**LOT #312**

## PATHWAYS 2

**MODEL - MADISON (43-10)**

## KITCHEN / VANITIES

#### 4 BDRM VANITIES

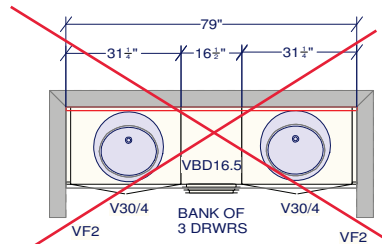
~~2ND SINK ADDED~~

KITCHEN - 3D VIEW #2

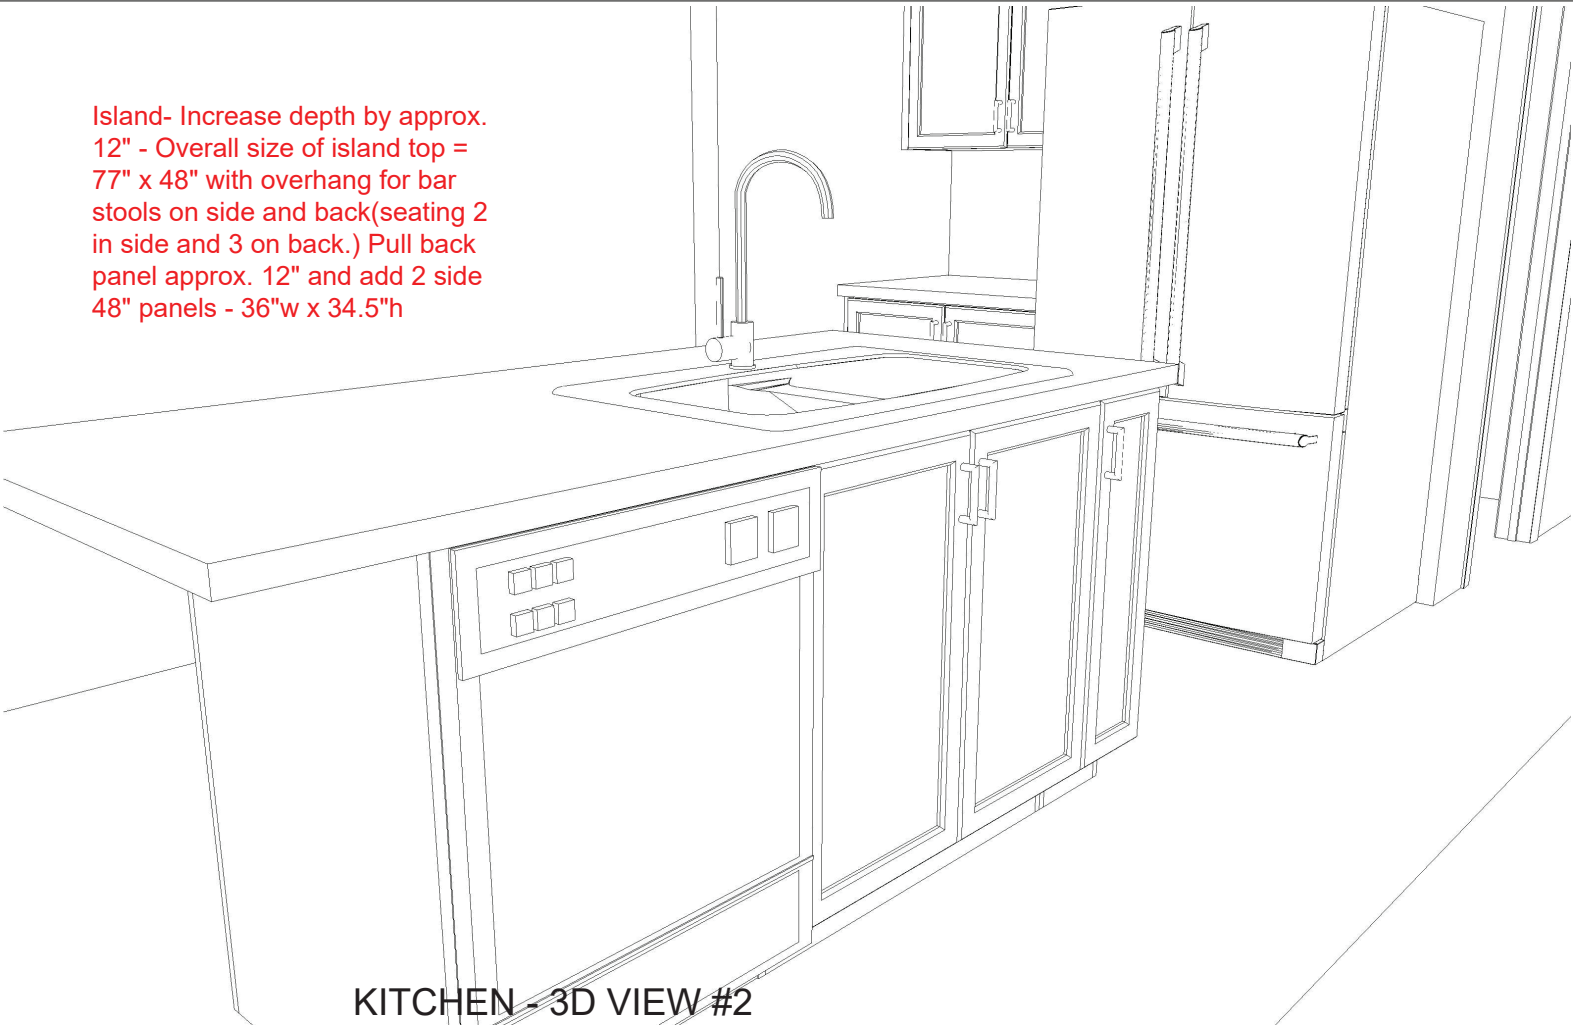
Island- Increase depth by approx.  
12" - Overall size of island top =  
77" x 48" with overhang for bar  
stools on side and back(seating 2  
in side and 3 on back.) Pull back  
panel approx. 12" and add 2 side  
48" panels - 36"w x 34.5"h

RANGE ELEVATION

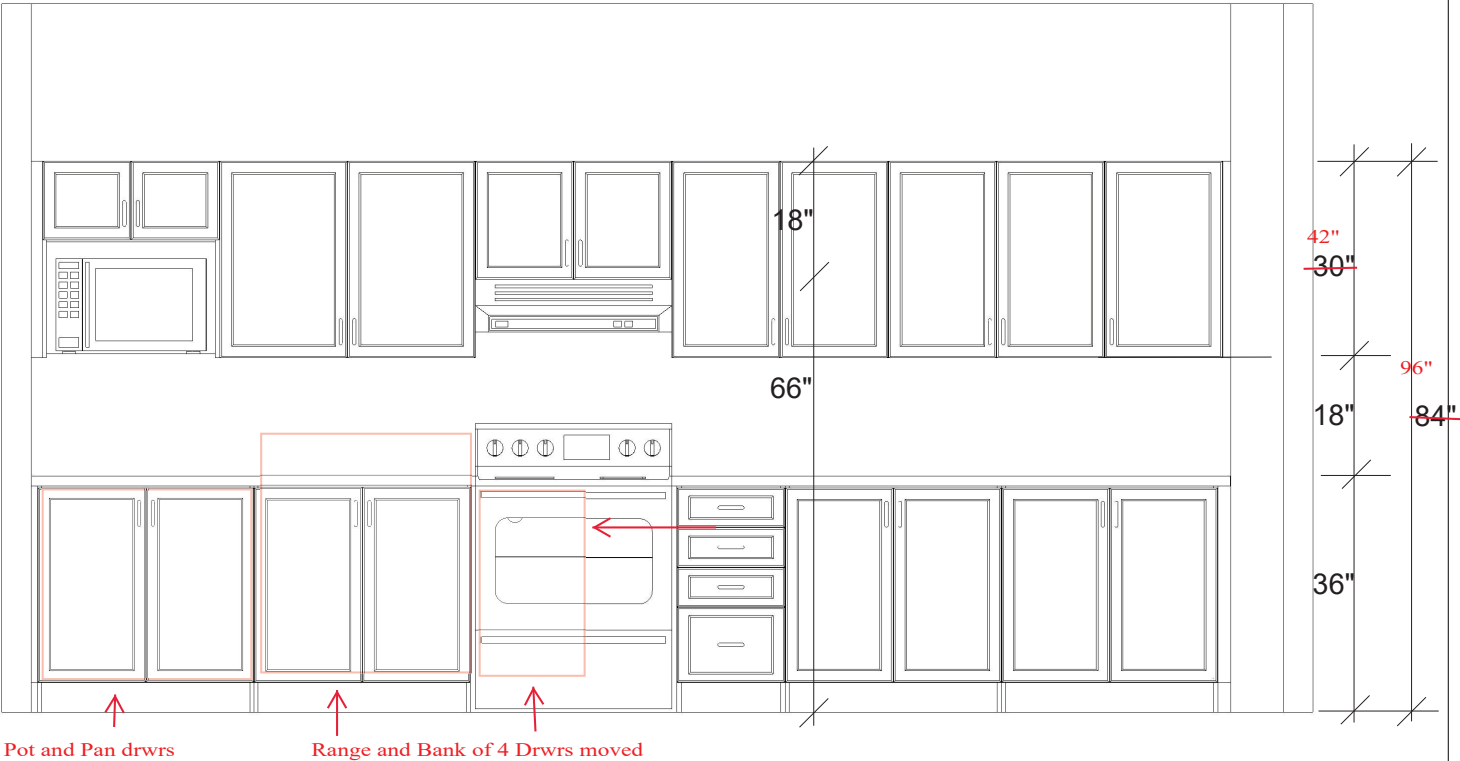
Pot and Pan drwrs

Range and Bank of 4 Drwrs moved
